LINCOLN PARK PLANNING COMMISSION

AGENDA

Conceptual Site Plan Review

Applicant	Channel Brawner, represented by Sketch Design Group, LLC
Project	Childcare Center
Address	1336 Southfield Road, Lincoln Park, MI 48146
Date	April 12, 2023
Request	Conceptual Site Plan Review

**PRELIMINARY
SITE PLAN**

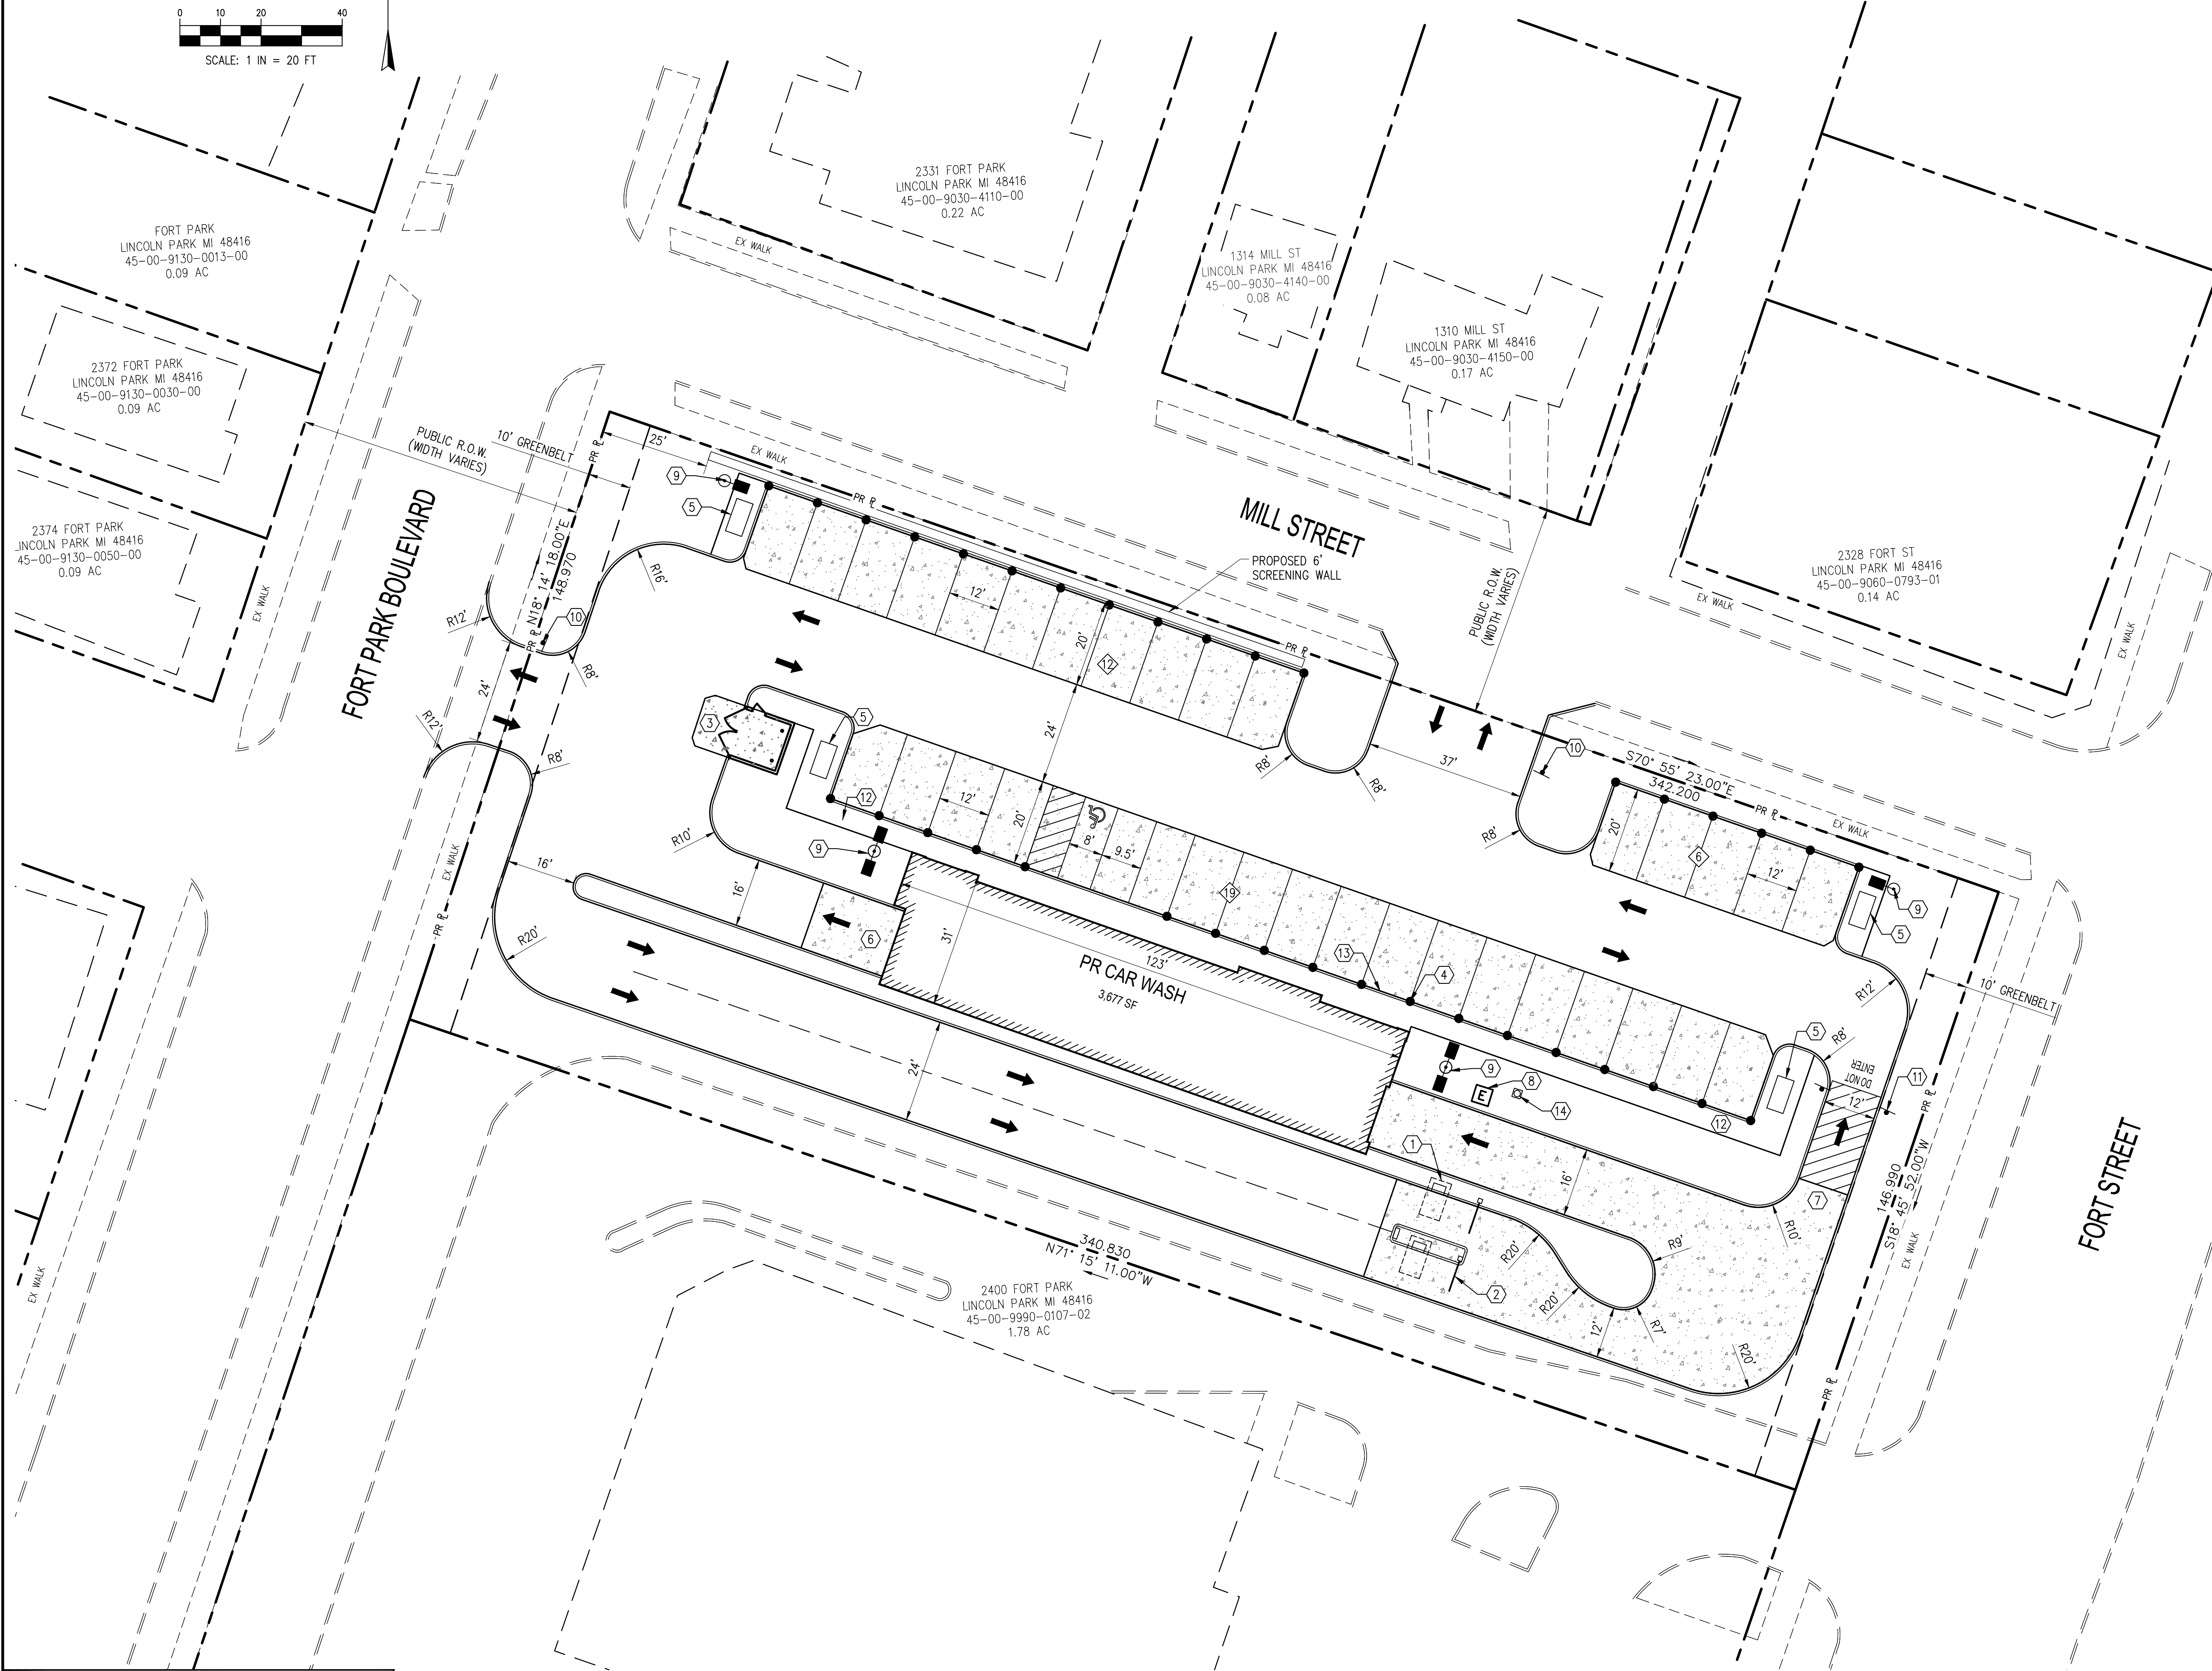
Use	Required	Proposed	Compliance
Automobile wash establishments (automatic)	Two (2), plus one (1) for each employee and manager, plus a minimum of sixteen (16) for cars waiting to be washed for each conveyor system, plus one (1) upon exiting each conveyor system, plus two (2) for post-wash detailing. <i>Total employees = 7</i> <i>Required parking spaces = 2 + (7 * 1) + 1 + 2 = 12 spaces</i> <i>Required stacking spaces = 16</i>	35 parking spaces; No stacking spaces indicated on plan.	NOT MET

Required	Proposed	Compliance
Parking Area Type B §1290.05	Adequate means of ingress and egress shall be provided and shown	Two entrances to the facility proposed via Mill Street and Fort Park Boulevard; A right-out exit lane is proposed on site for vehicles that are unable to move into the car wash tunnel.	Met
	Parking facilities, access drives, and maneuvering aisles shall be hard surfaced with concrete or plant-mixed bituminous material, maintained in a usable dustproof condition and graded and drained appropriately	Concrete pavement proposed for all parking areas and asphalt pavement proposed for driveways. Grading and drainage indicated along all driveways and parking facilities.	Met
	Concrete curbs and gutters	Concrete curbs and gutters proposed.	Met
	When adjoining residential property and/or a residential street or alley: 6' solid masonry wall, ornamental on both sides, with bumper guards	Proposed 6' screening wall west of Mill St. ingress/egress; no screening proposed on Fort Park Blvd. No material details provided.	NOT MET

- Applicant shall provide the required stacking spaces with dimensions to comply with the regulations in §1290.02.
- Applicant shall provide details on materials used to construct the proposed 6-ft screening wall along Mill Street.

- Applicant shall provide the required screening along Fort Park Boulevard, in compliance with §1294.28.

Required	Proposed	Compliance
Setback	Building >20' from street lot line	Not Indicated; Unable to determine setbacks from as drawing scale doesn't match indicated measurements.	INQUIRY
Stacking Spaces	<ul style="list-style-type: none"> • Number: 16 per wash line, plus 1 upon exit • Size: 10 ft. wide x 24 ft. long • Do not include use of any public space, street, alley, or sidewalk 	No stacking spaces or dimensions shown on plan.	INQUIRY

- Applicant shall submit scaled drawings.
- Applicant shall provide the required stacking spaces with dimensions to comply with the regulations in §1290.02.

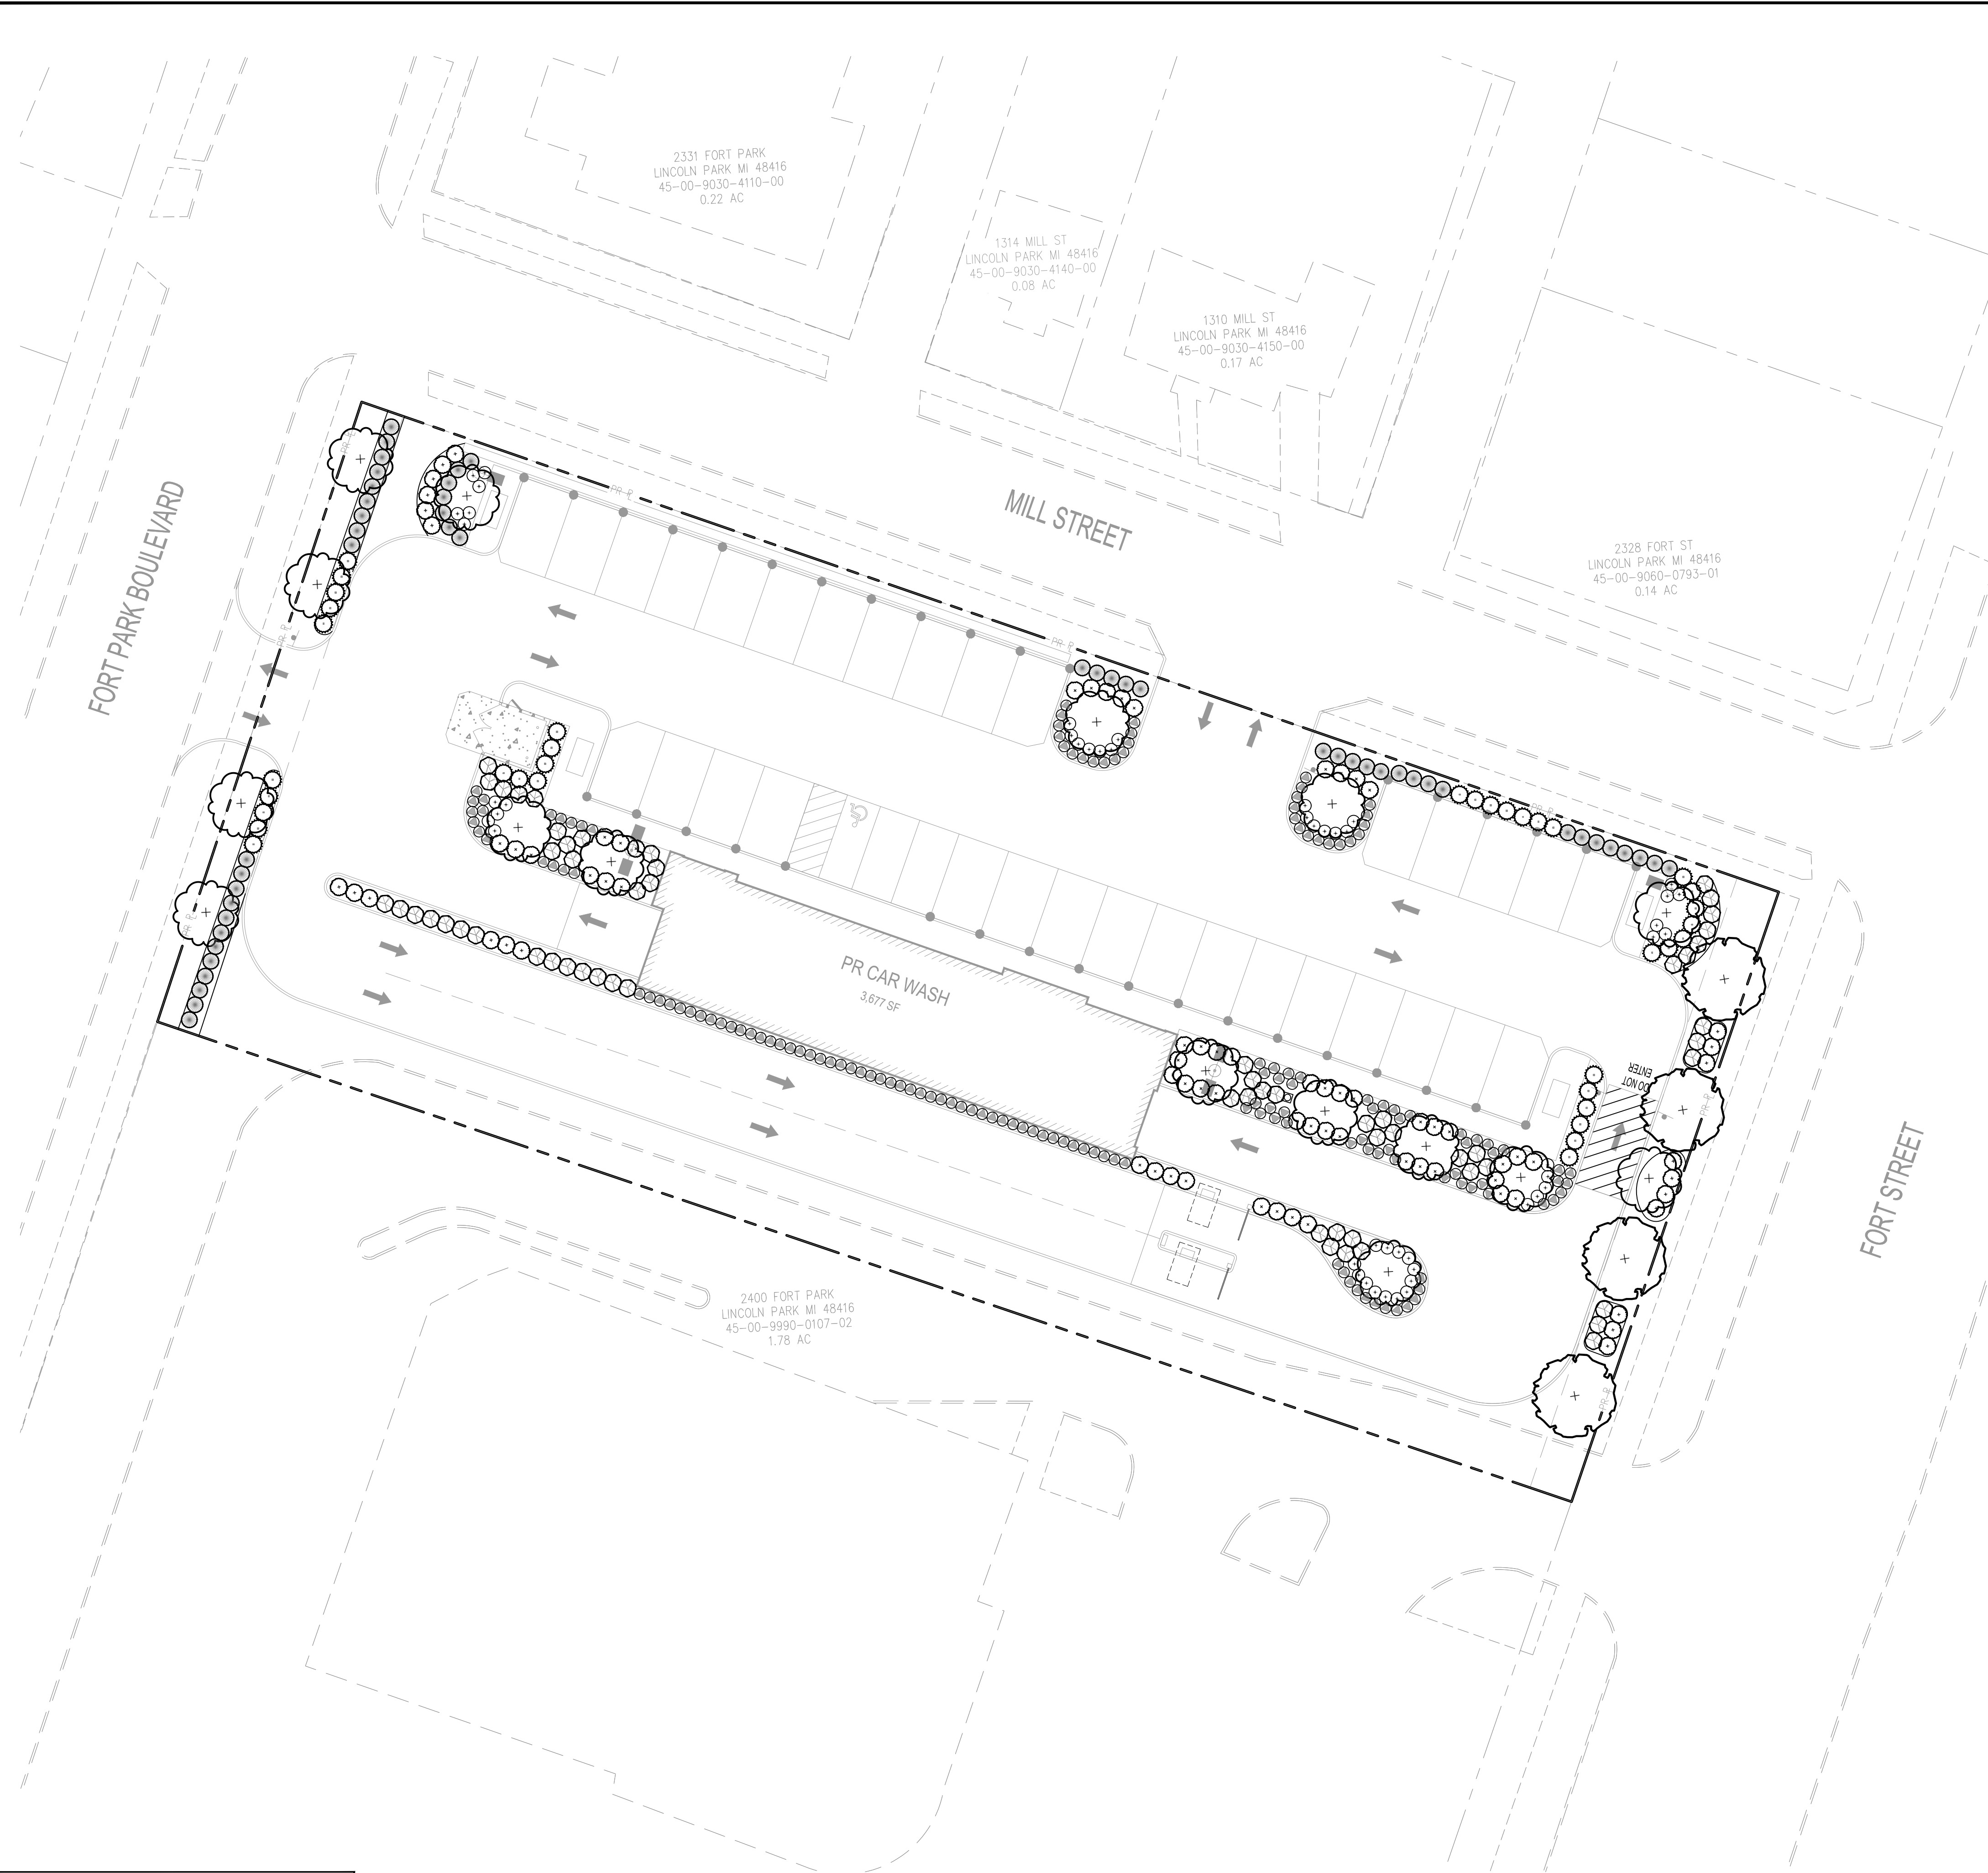
Required	Proposed	Compliance
	1 tree per 400 sf of required landscaping and 1 shrub per 250 sf of required landscaping. <i>5,053/400 + 5,053/250 = 13 trees + 20 shrubs</i>	3 trees and >20 shrubs	NOT MET
Parking Lot	1 deciduous or ornamental tree per 10 parking spaces < 10 parking spaces <i>Total 35 parking space</i> <i>Required trees = 35 / 10 = 3.5 = 4 trees</i>	4 trees proposed; Unable to determine planting area.	INQUIRY
	100 sf of planting area per tree		
Screening	Waste receptacle: Decorative masonry wall of at least 6' with solid or impervious gate	Sheet C200 notes that a dumpster will be located outside the building, but no details provided.	INQUIRY
	Abutting residential: greenbelt, 15' with 5' evergreens (PC may waive), and/or solid 6' masonry wall ornamental on both sides	Proposed 6' screening wall west of Mill St. ingress/egress; no screening proposed on Fort Park Blvd. No material details provided.	NOT MET

The proposed project is a new development on a vacant site; therefore, it must meet all landscaping requirements. There is adequate space to provide the required number of street trees and interior landscaping trees. While there is a proposed screening wall for the residential properties on Mill Street, there is no proposed screening for the residential properties on Fort Park Blvd. Additionally, an accurately scaled landscape plan is required to evaluate compliance with interior landscaping and parking lot planting standards.

- Applicant shall provide accurately scale landscape drawings to calculate interior landscaping and parking lot plating areas.
- Applicant shall provide height and species details for proposed landscaping.
- Applicant shall revise the landscaping plan to add an additional 13 trees to comply with the street and interior landscaping requirements.
- Applicant shall provide dumpster screening wall and enclosure details.
- Applicant shall provide details on materials used to construct the proposed 6-ft screening wall along Mill Street.
- Applicant shall provide the required screening along Fort Park Boulevard, in compliance with §1294.28.

Sheet L100 notes evergreen screening will be provided for mechanical equipment will be screened; however, no details on location of mechanical equipment or screening details provided.

- Applicant shall show proposed mechanical equipment with the required screening on the site plan.*
